Re: Dash 4 Canna

1302 Broadway Blvd. NE

**30-Day Temporary Certificate of Occupancy Transportation Development Final Inspection** Architect's Stamp dated 04-09-24 (J14-D122)

C100 SITE PLAN & SECTIONS

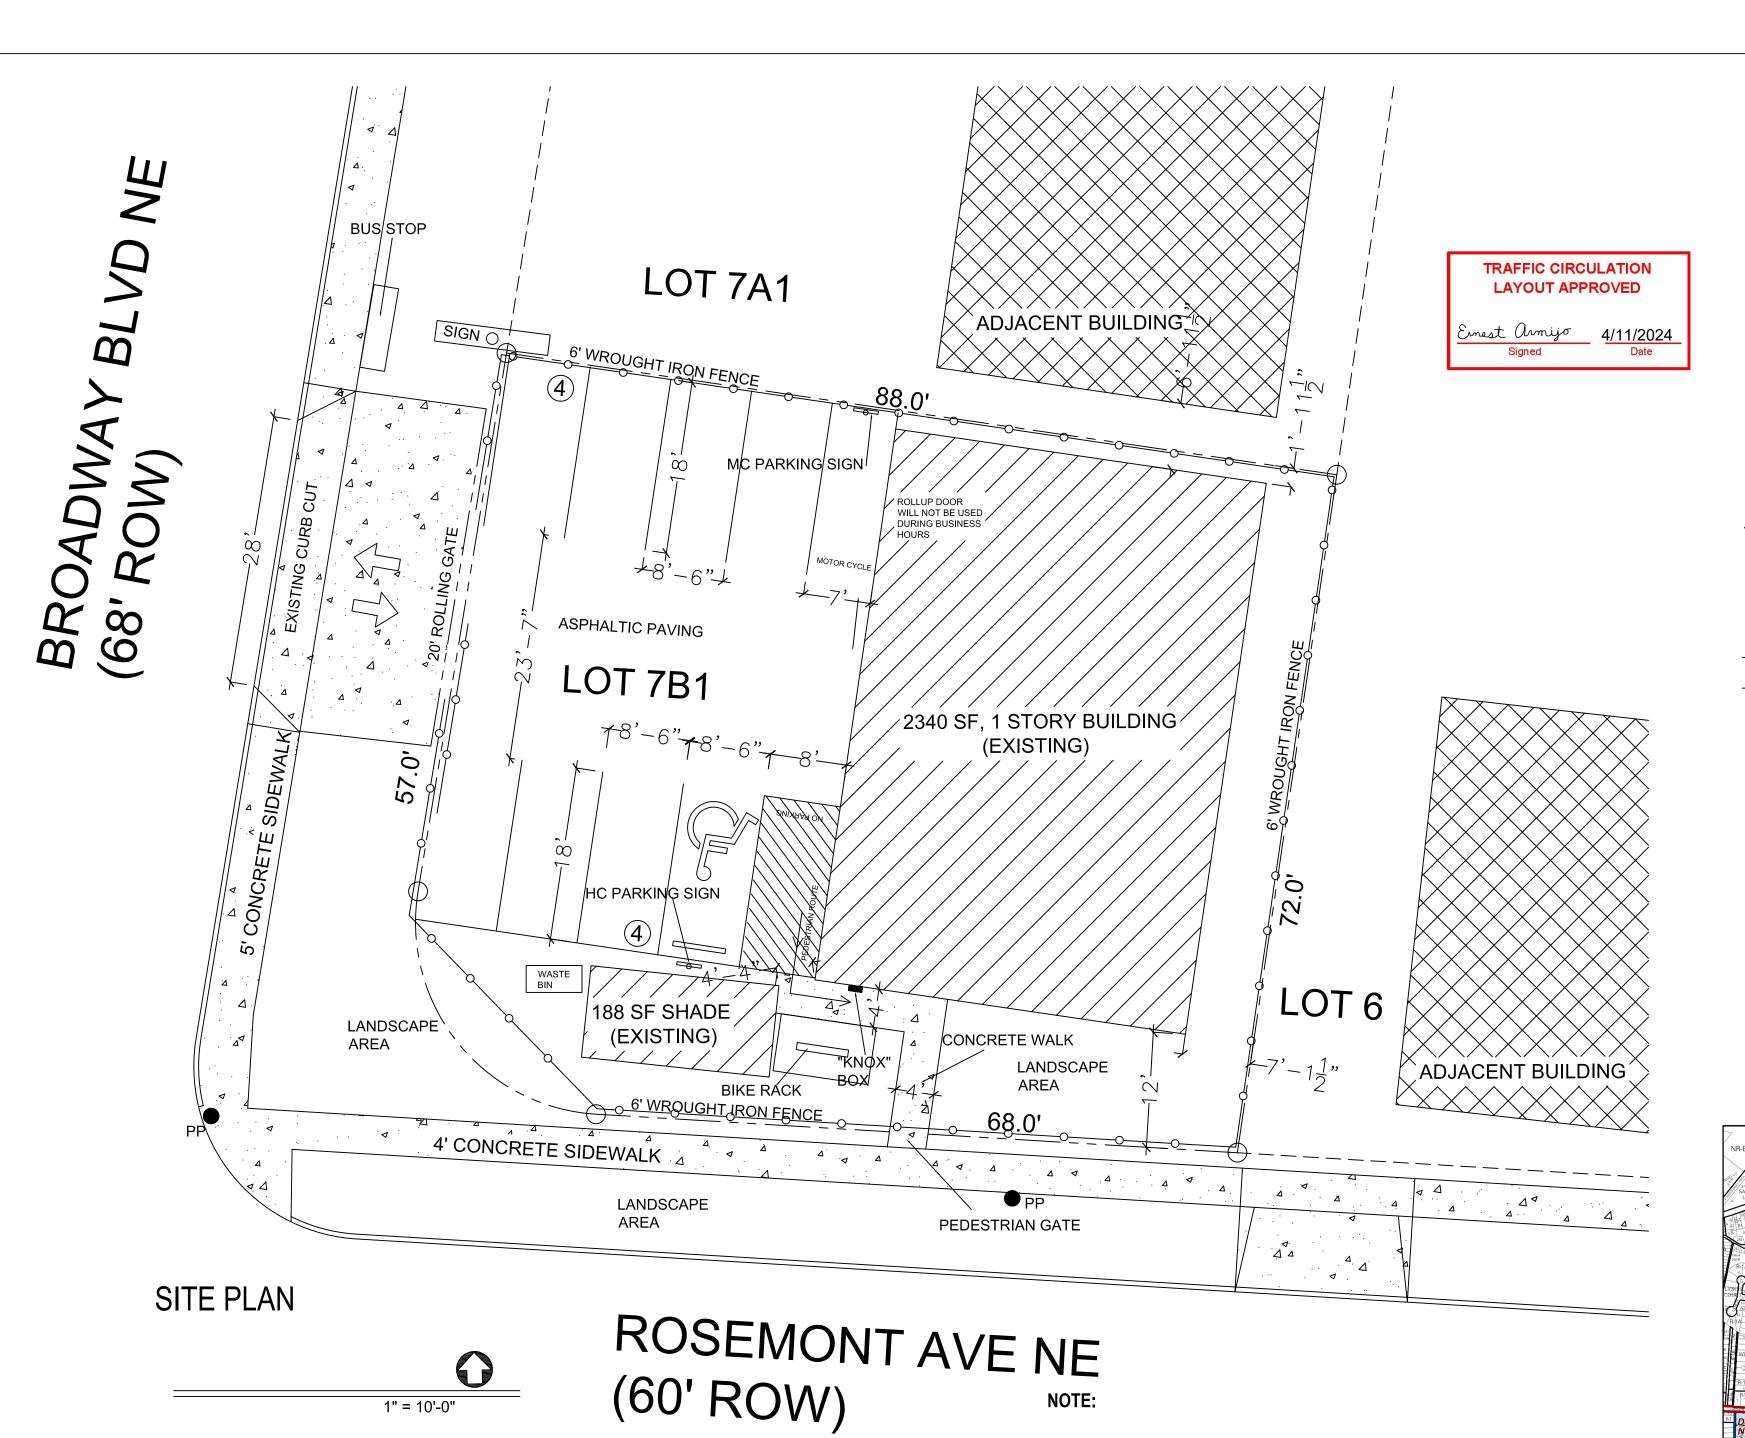
Per the approved site plan: The pedestrian pathway from the public sidewalk to the entrance, must be constructed.

- Concrete walk to Rosemont was not installed as gate will remain locked.

Once these corrections are complete, email pictures to <a href="mailto:malnajjra@cabq.gov">malnajjra@cabq.gov</a> for release of Final CO.
